Re: Gainesville Regional Utilities
Deerhaven Generating Station
Title V Permit No. 0010006-003-AV

The purpose of this letter is to provide comments to the Department on the above referenced draft Title V permit. Specific comments are detailed below.

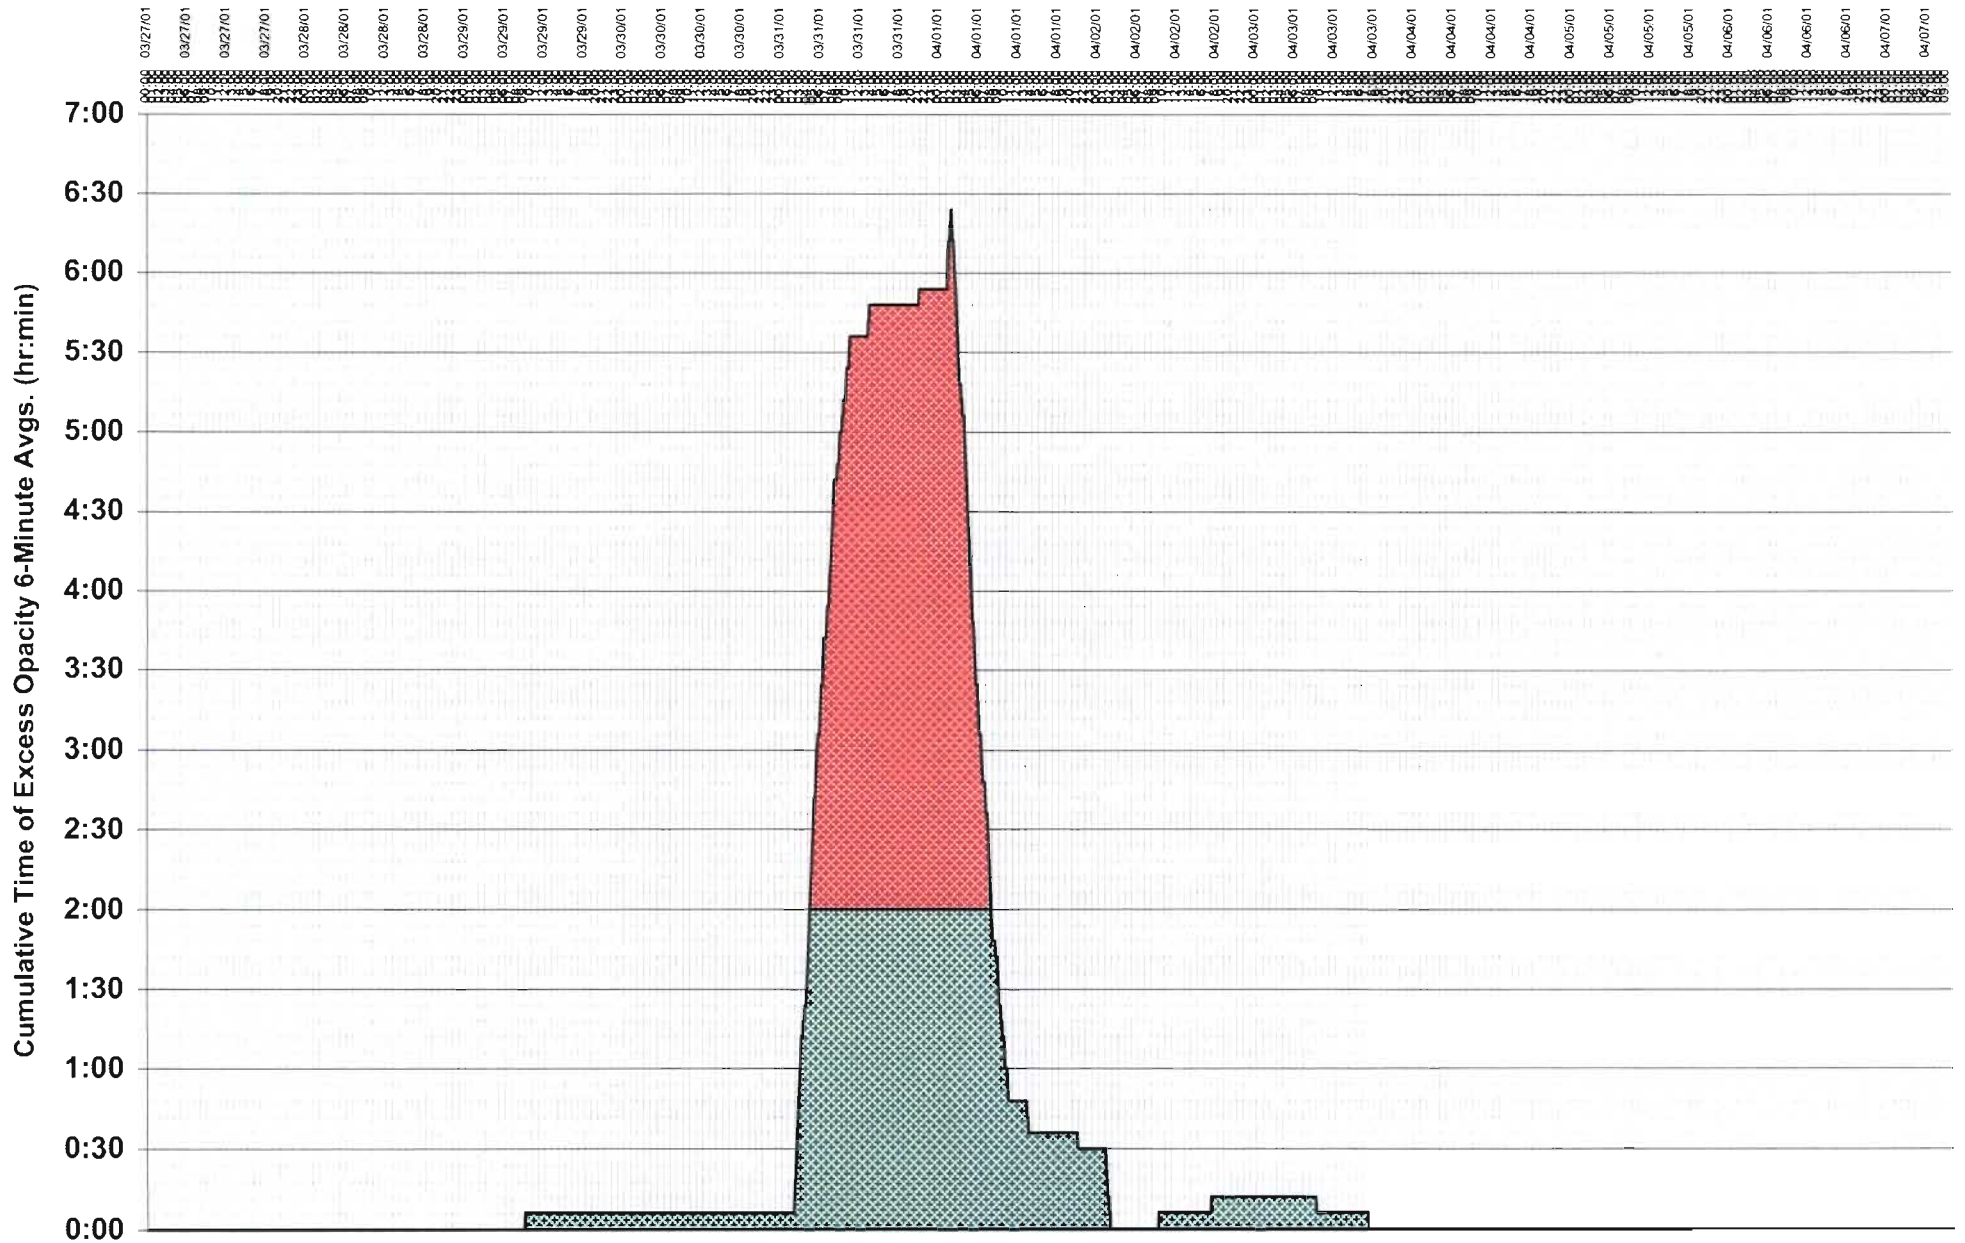
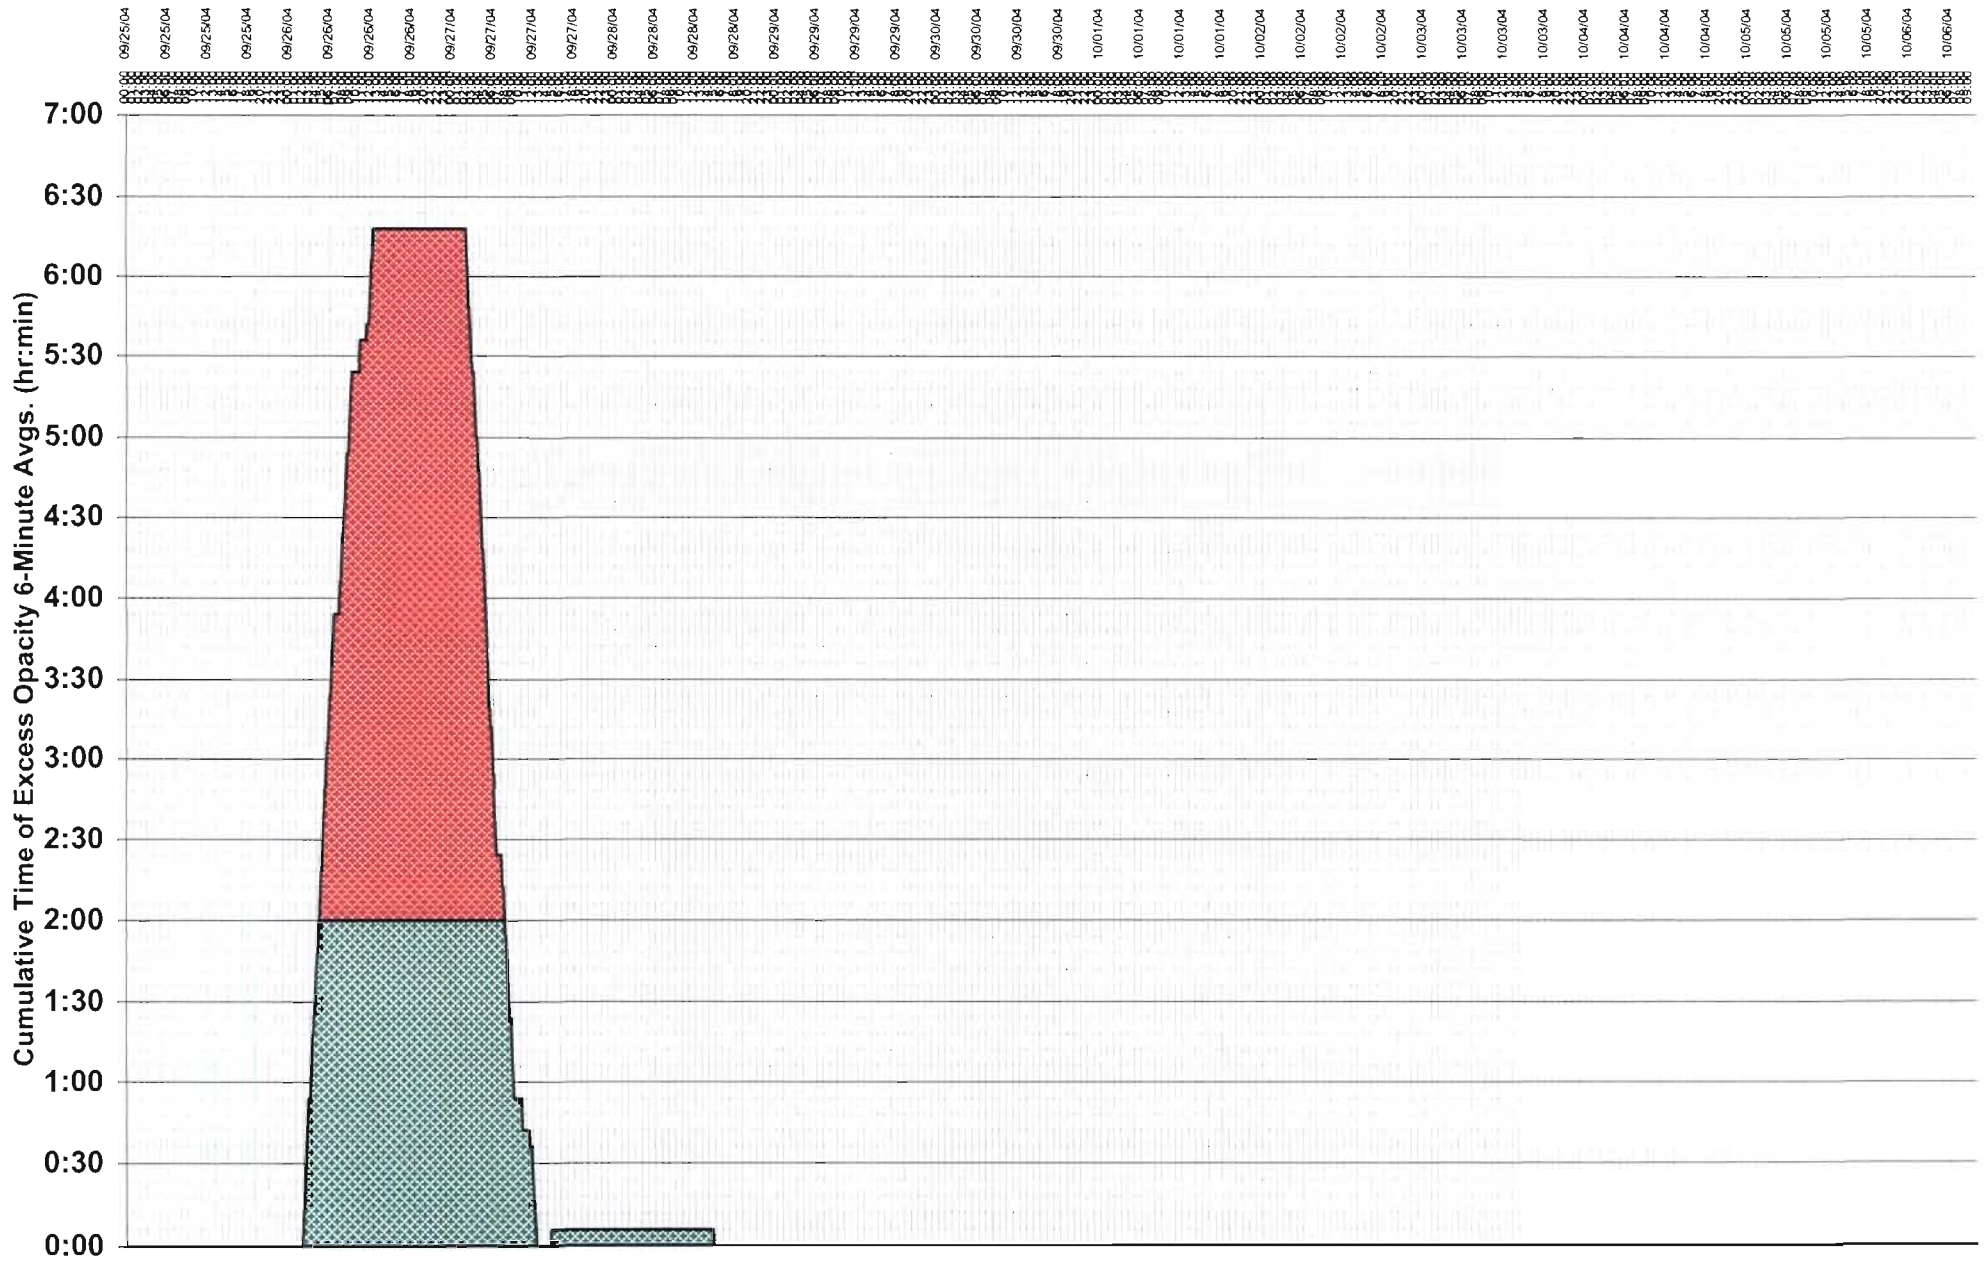
3.) During the shutdown of Unit #2, excess emissions of opacity are unavoidable due to safety related and operational issues. Specifically, the precipitator must be de-energized until the boiler, the ductwork leading up to the precipitator, and the precipitator itself are purged of combustibles to avoid a fire in these pieces of equipment. However, after this purging is complete, the precipitator is re-energized. Operationally, as the hot components of the boiler and related ductwork cool, the gas that is passing through the precipitator is also cooling. As a result, the precipitator is operating in a temperature regime that is does not allow it to perform at its design efficiency, which results in excess opacities.

A review of the last four shutdowns for annual maintenance reveals that the maximum time of excess opacities in any 24 hour period ranges from 6 hours and 18 minutes in 2002 to 11 hours and 24 minutes in 2004. Please find attached graphical representations of the last four shutdowns for annual maintenance (2001, 2002, 2003, and 2004). Therefore, GRU requests that Specific Condition D.2. be modified to allow for 12 hours of excess opacities during shutdown of Unit #2. Amended language is provided below.

D.2. Excess emissions resulting from startup, shutdown, or malfunction shall be permitted provided that best operational practices to minimize emissions are adhered to and the duration of excess emissions shall be minimized but in no case exceed two hours in any 24 hour period except for Unit #2 where excess emissions of opacity shall not to exceed 12 hours in any 24 hour period only during shutdown of the unit unless specifically authorized by the Department for longer duration.
